**ADDENDUM TO INITIAL STUDY/
MITIGATED NEGATIVE DECLARATION
(SCH No. 2011061047)**

**SANTA MONICA PIER EMERGENCY GANGWAY
& PHASE 4 STRUCTURAL UPGRADE PROJECT**

1 CONCEPT TRESTLE AND CONSTRUCTION BARRIER PLAN
 SP-2 SCALE: 1"=30'

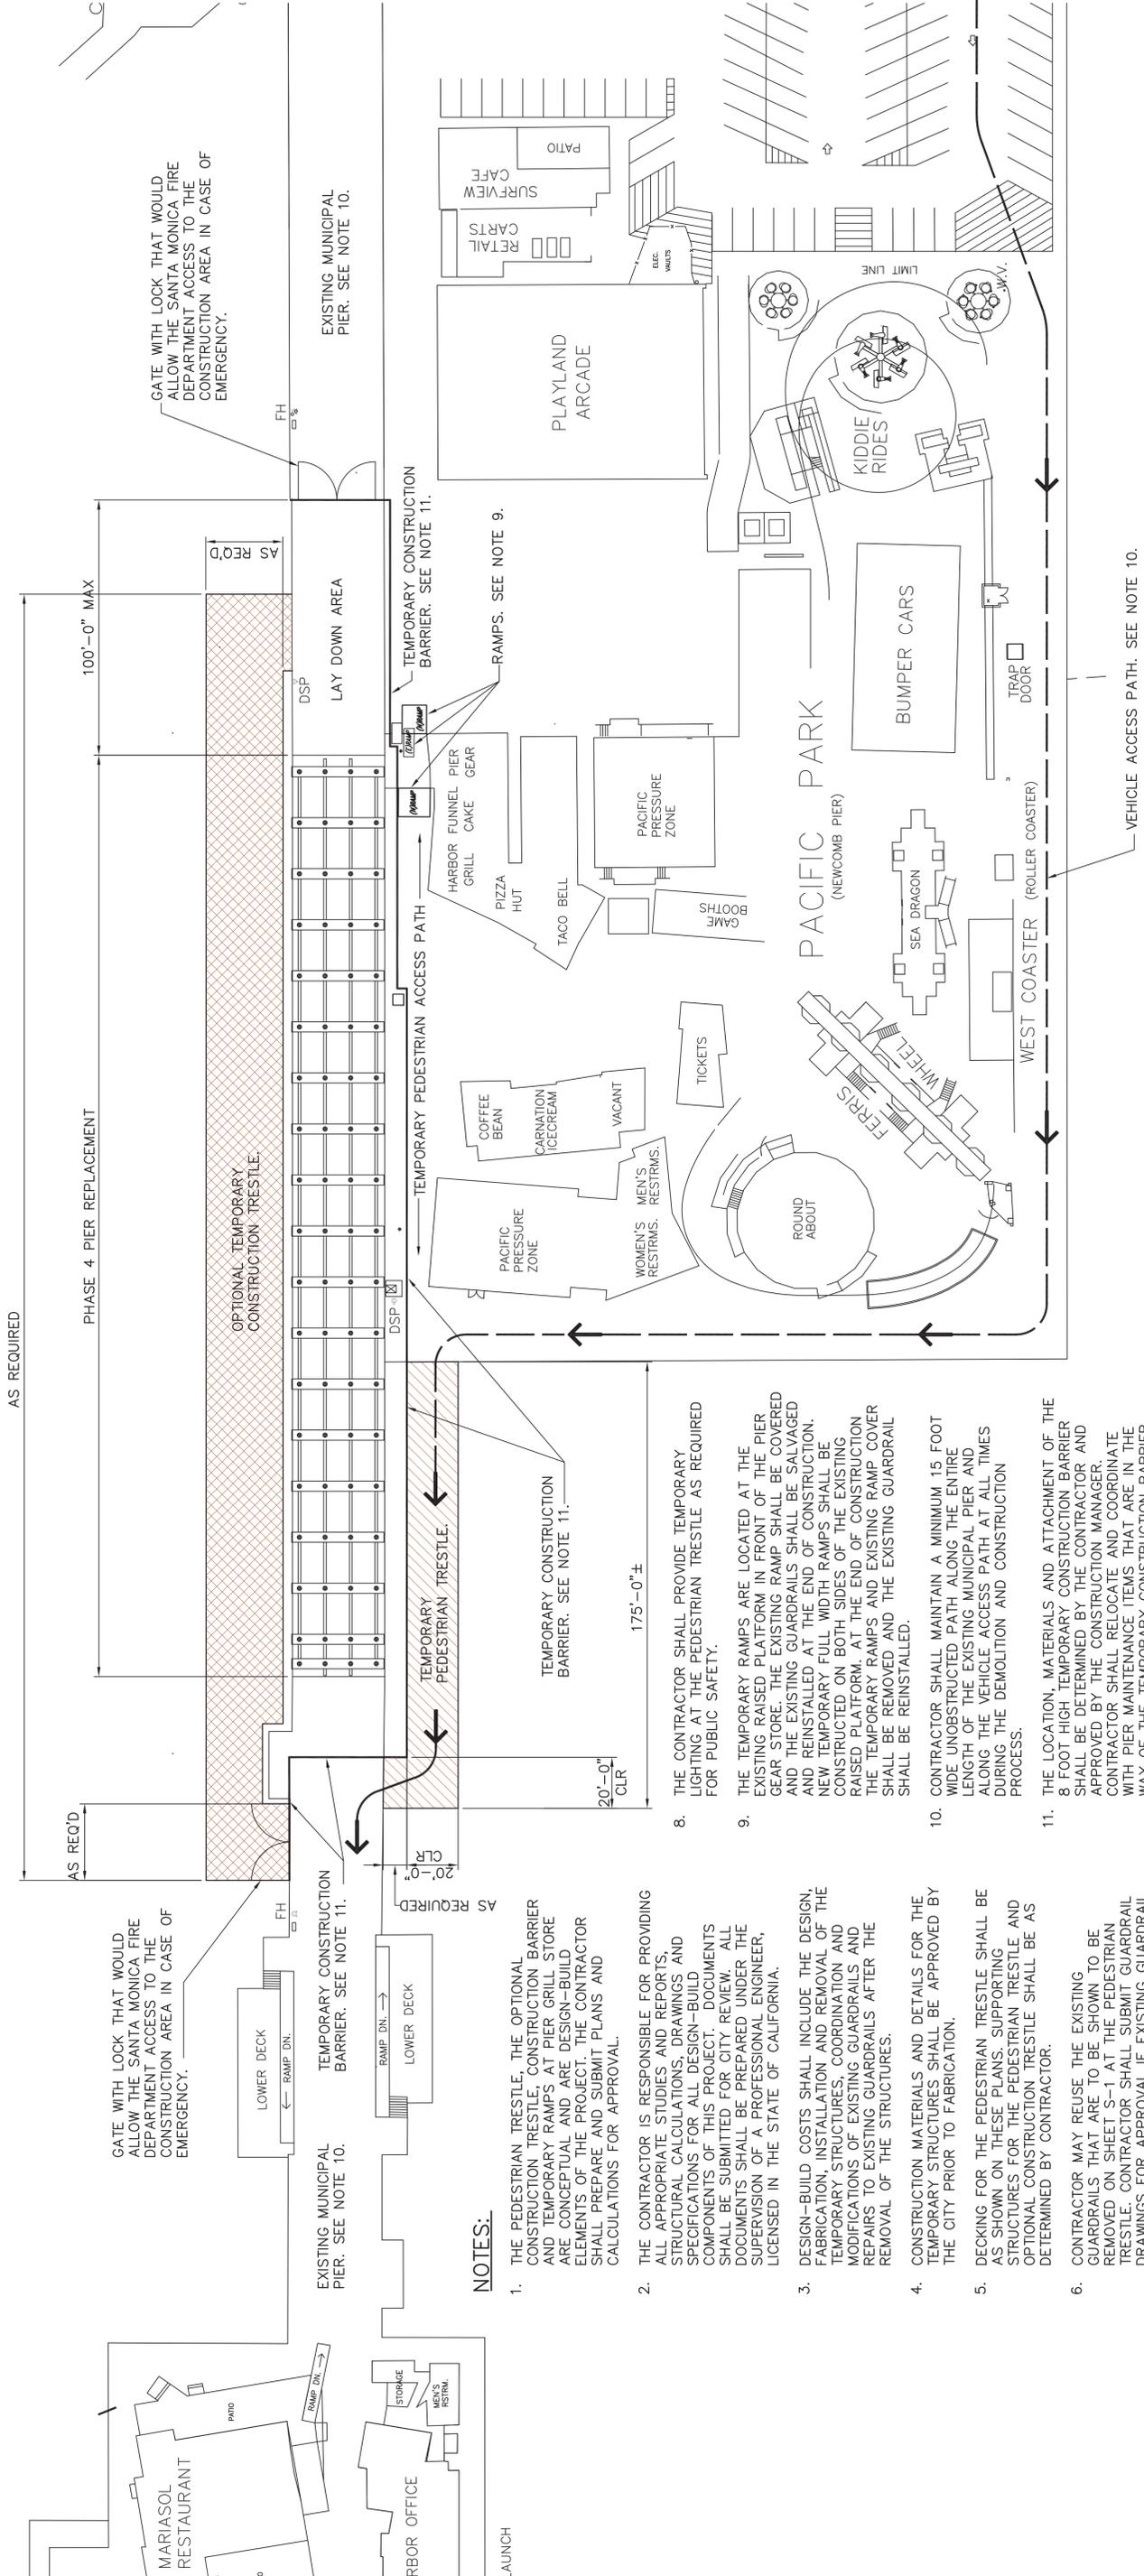
The construction plans (attached hereto and labeled Exhibits SP-1 and SP-2) indicate the provision of a "Temporary Pedestrian Access Path" through parts of the adjacent retail and amusement park leased area. The plans call for the altering of parts of the adjacent leased area to help allow additional pedestrians to maintain access to affected businesses. These alterations to the adjacent business owners' leased areas would only be done with written permission from the affected owners. The 15-foot pedestrian access (as required by the IS/MND) will remain available as shown in the attached exhibits; it should be noted that the pedestrian access described in the IS/MND included both the Municipal Pier and Newcomb Pier. It should also be noted that Exhibits SP-1 and SP-2 indicate that the existing access route along the southern and western edges of the Newcomb Pier (west of the Pier parking lot) is designated as a "vehicle access path," though this right-of-way would be utilized for temporary pedestrian access during construction activities, while also providing emergency vehicle access, as necessary.
